WELLINGTON CITY COUNCIL

Proposed District Plan

Report and Recommendations of Independent Commissioners

**Overview of General Matters
High Density Residential Zone
Medium Density Residential Zone
Residential Design Guide
Large Lot Residential Zone**

Figure 1 – Before Rezoning Lot 5 DP 524106

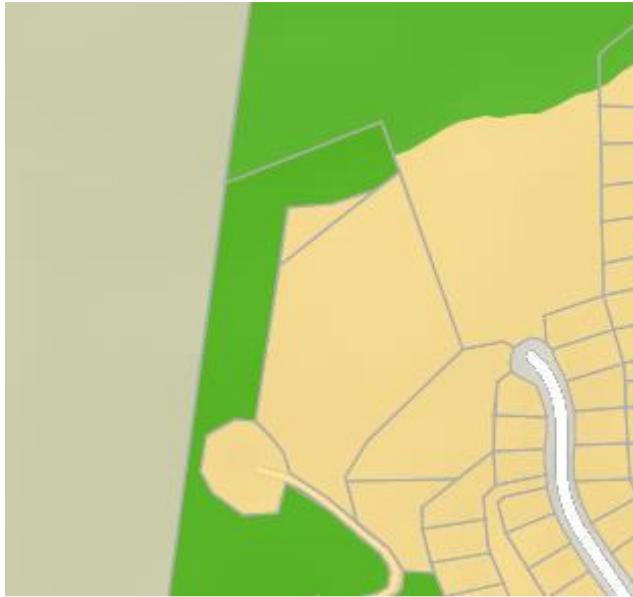
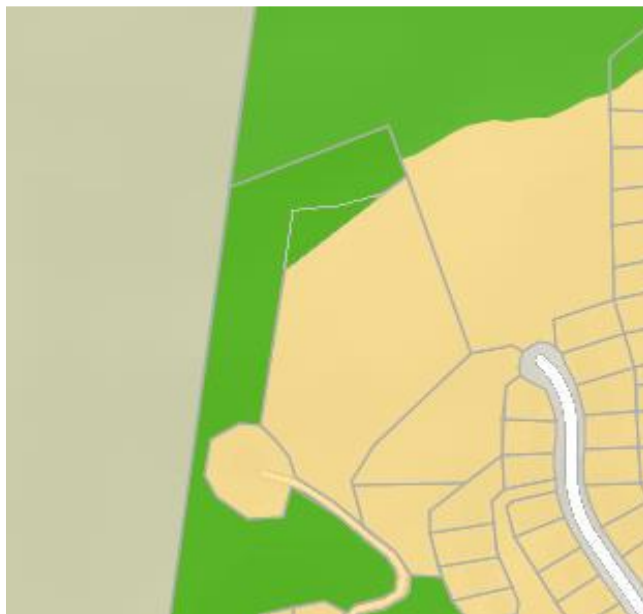
282. In relation to the other issue Mr Halliday raised concerning zone and property boundary alignment on Atherton Terrace, Mr Patterson also agreed that the alignment should occur, and produced the following figures illustrating the point:

Figure 5 – Before Rezoning

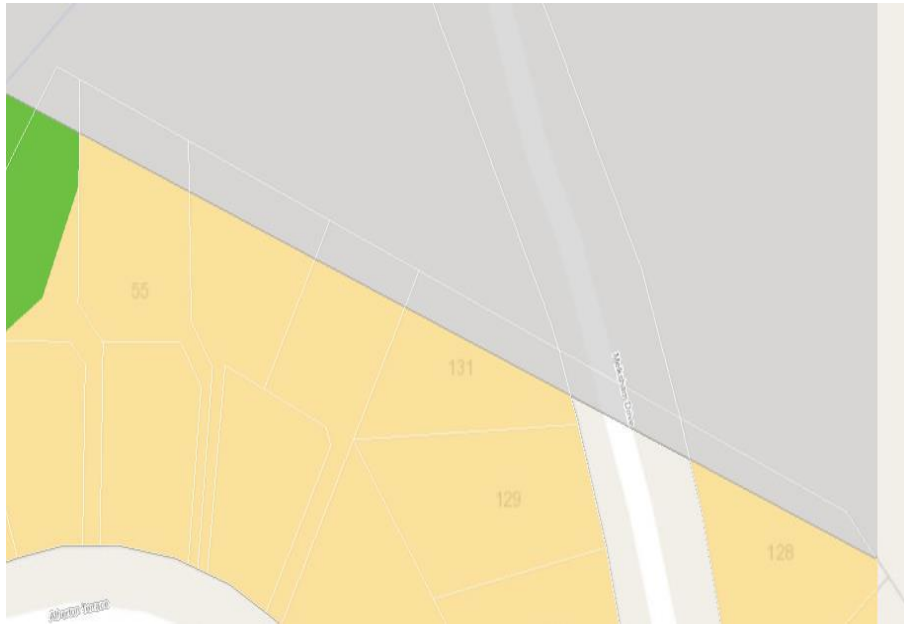
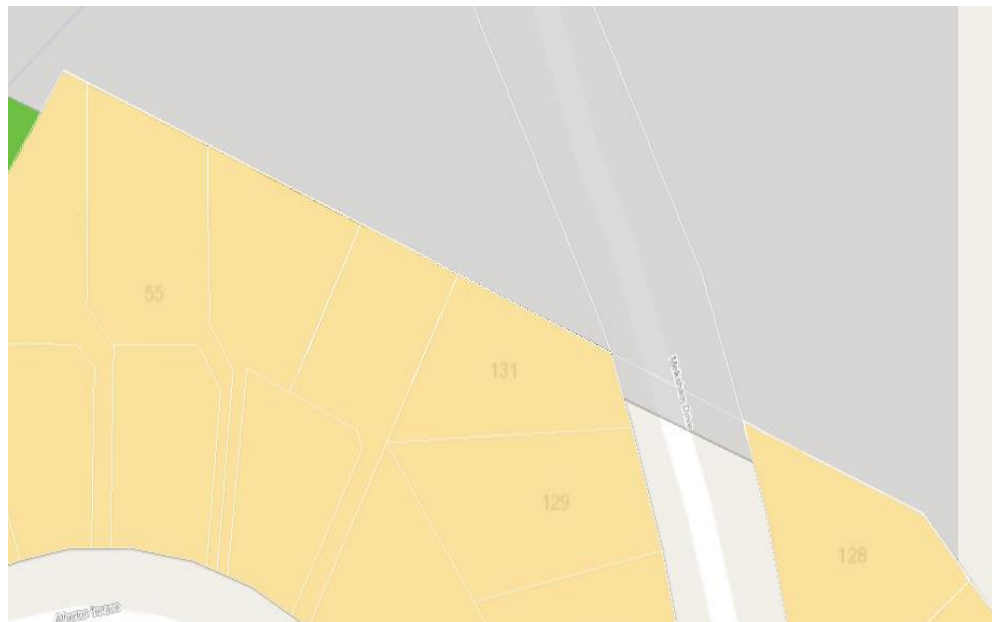
283. While Mr Patterson was amending the zoning to align with property boundaries, he noted that there are several properties, also on Atherton Terrace, and on Melksham Drive, which have a similar issue with the Future Urban Zone protruding over back boundaries²⁹³, and recommended that these properties are also rezoned as shown below:
